## HISTORIC AND DESIGN REVIEW COMMISSION

Agenda Item No: 21

**HDRC CASE NO:** 2016-452  
**COMMON NAME:** 100 N Main  
**LEGAL DESCRIPTION:** NCB 909 BLK LOT A8 & A 9  
**ZONING:** D S H HE RIO-3  
**CITY COUNCIL DIST.:** 1  
**DISTRICT:** Main/Military Plaza Historic District  
**LANDMARK:** Bell Furniture / Wolfson's  
**APPLICANT:** Randy Kelly/JRK Design  
**OWNER:** REM Hospitality  
**TYPE OF WORK:** Approval of signage master plan, landscaping, street level elements  
**REQUEST:**

The applicant is requesting a Certificate of Appropriateness for outstanding items specific to the new construction at 100 N Main. At this time, the applicant is requesting a Certificate of Appropriateness for:

**STEEL PAN  
STAIR C SECTION**  
3/8" = 1'-0"

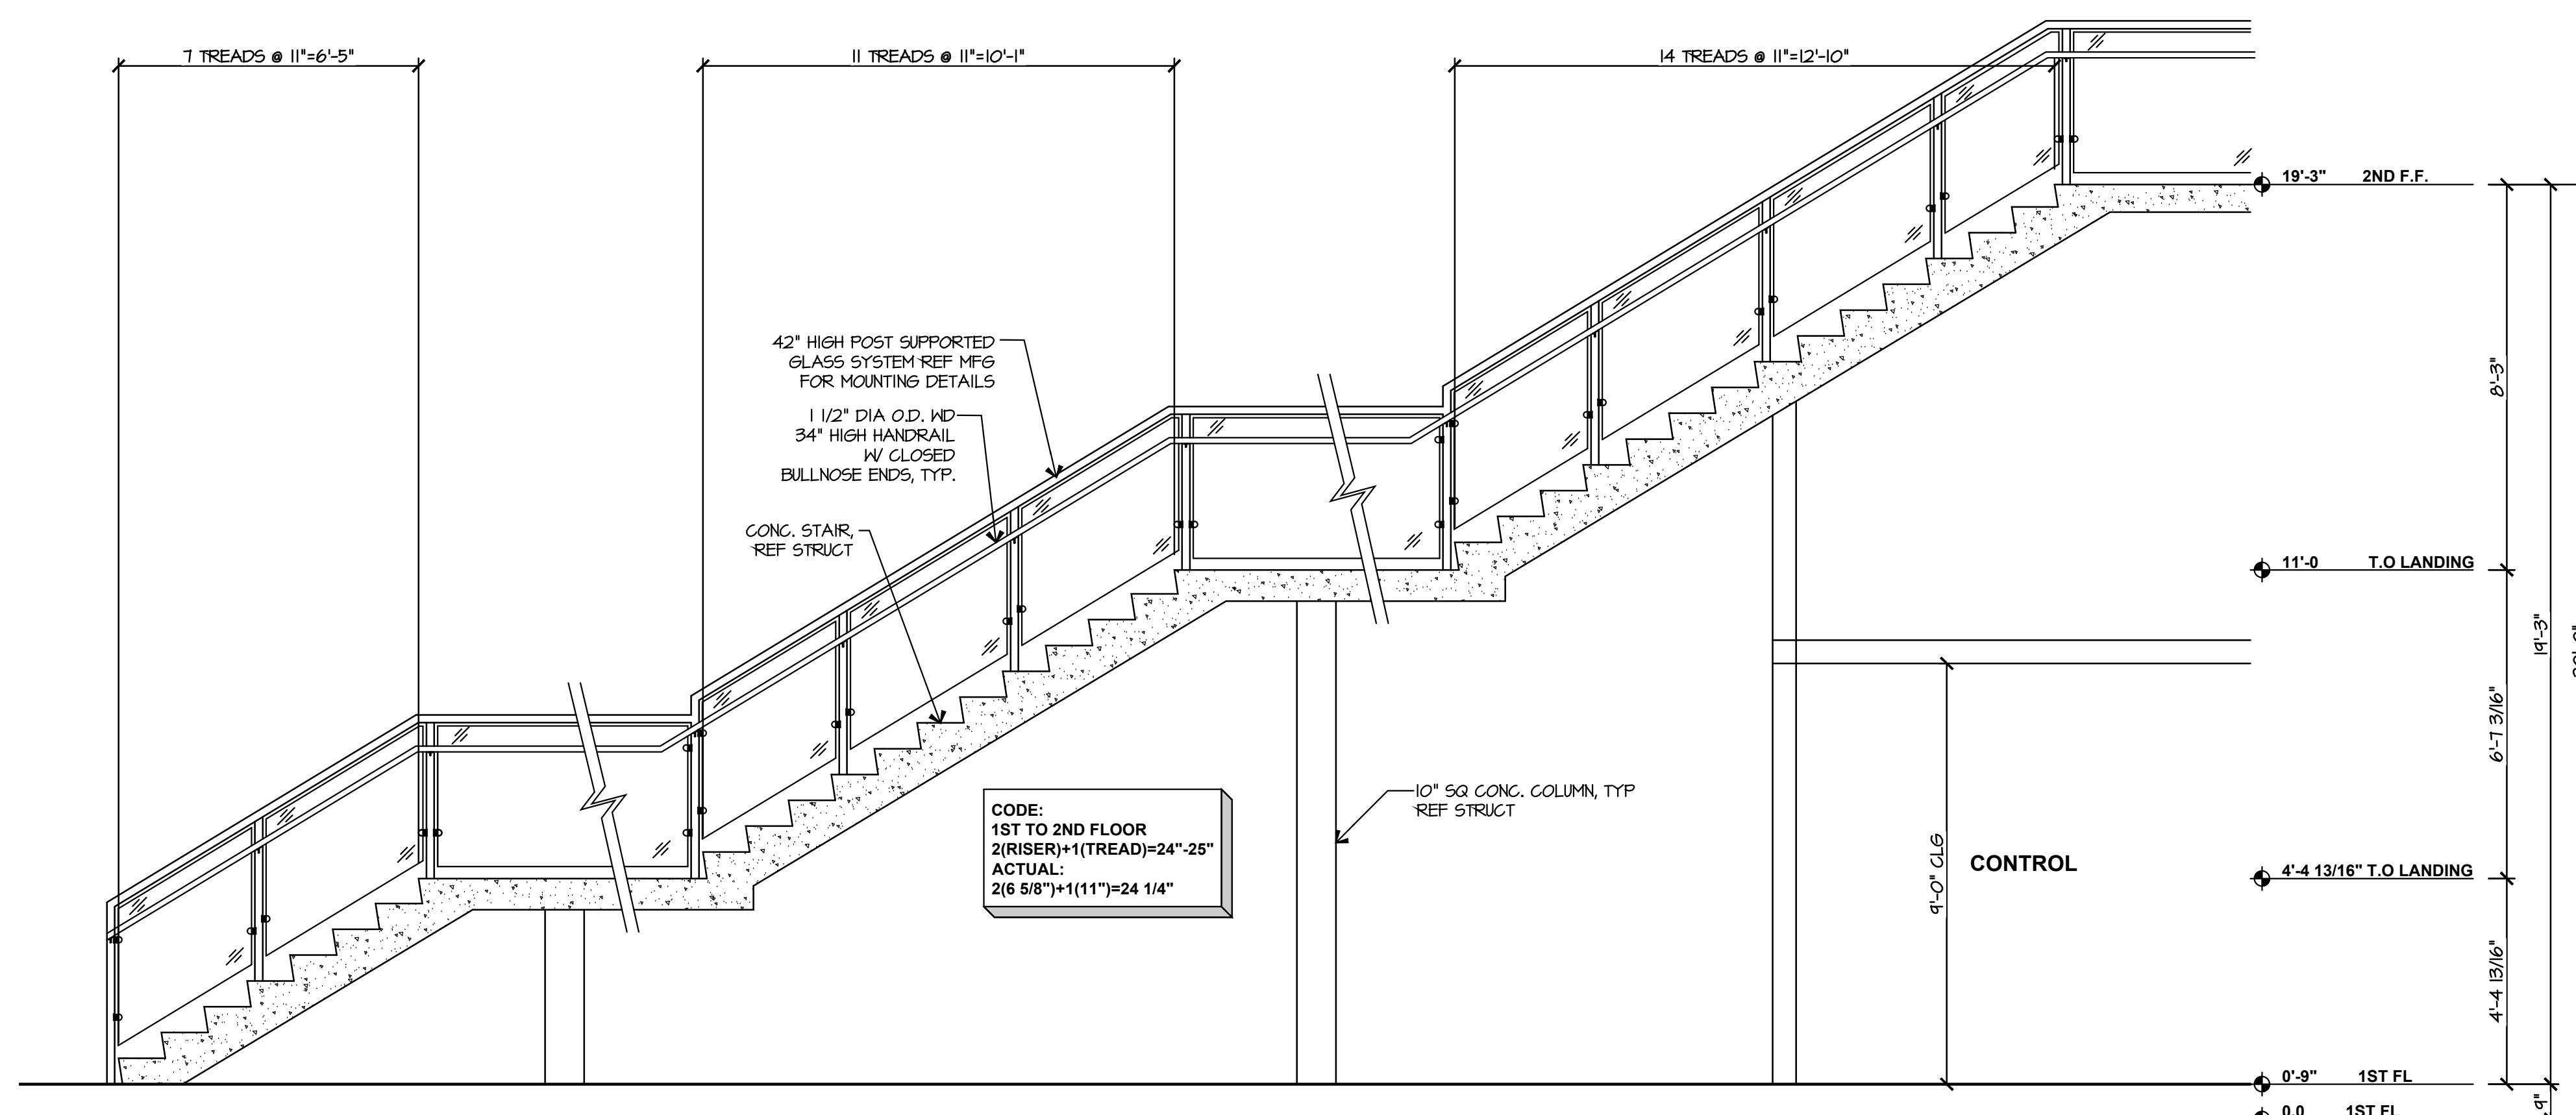
- b. STAIR DETAIL – At the street level, the applicant has provided a detail which notes the installation of a lockable gate which is to measure 56 inches in width and 84 inches in height. Staff finds that a gate exceeding six (6) feet in height at this location is inappropriate. Staff recommends the applicant reduce the height of the gate to not exceed six (6) feet in height. Additionally, the proposed gate should match the stair railings in materials, finishes and detailing.

1. See sheet A602 for the stair plan, elevation and section showing the gate and specs for the gate to secure the 2<sup>nd</sup> floor balcony after hours.
2. See civil drawing set in response to the side walk remaining at the constant level.
3. See Landscape plan and specs.
4. See A300 for the proposed exterior signage.

## E. COMMERCE STREET ELEVATION

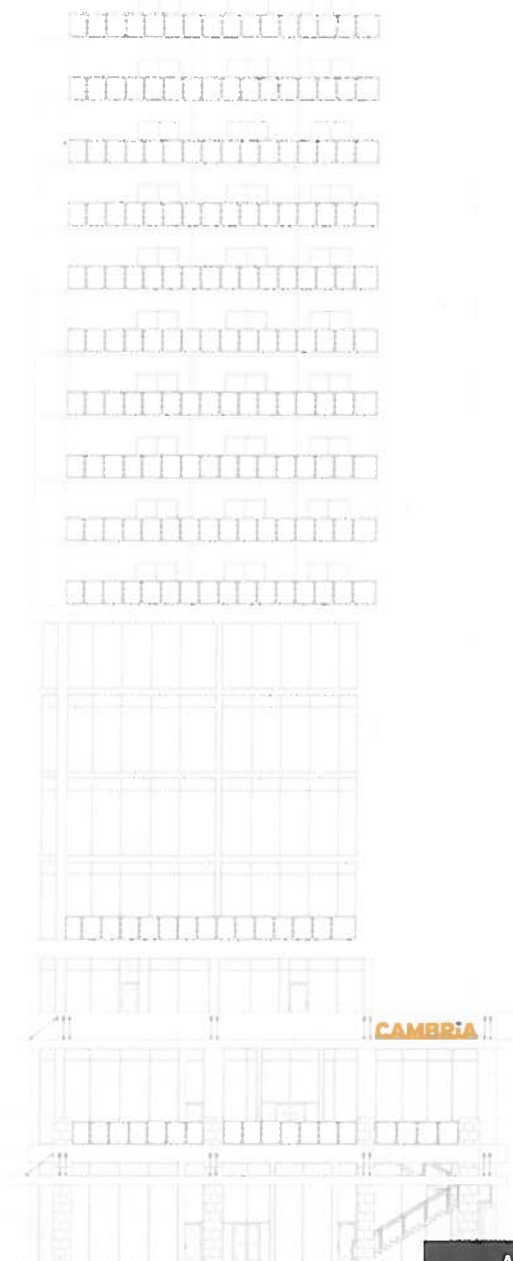
- g. MASTER SIGNAGE PLAN – The applicant has proposed signage on the south façade to measure 16' – 11" in width and 2' – 11" in height featuring fifty (50) square feet. Regarding the south facing signage, staff finds that given its location and proximity to Main Plaza, the applicant should reduce the overall square footage to no more than twenty-five square feet. Additionally, staff finds that this signage should feature reverse aluminum channel letters and be back lit by LED lighting.

- h. MASTER SIGNAGE PLAN – At the street level, the applicant has proposed signage for two tenants to be located beneath the previously approved canopy. The applicant has proposed for the corner tenant space to feature two signs; one along N Main and one alone E Commerce and for the adjacent tenant space to feature one sign to face

E Commerce. Staff finds that each sign should be mounted to the underside of each canopy and be constructed of aluminum, feature reverse channel letters and be internally illuminated. Staff recommends that each sign not exceed more than ten (10) square feet total.
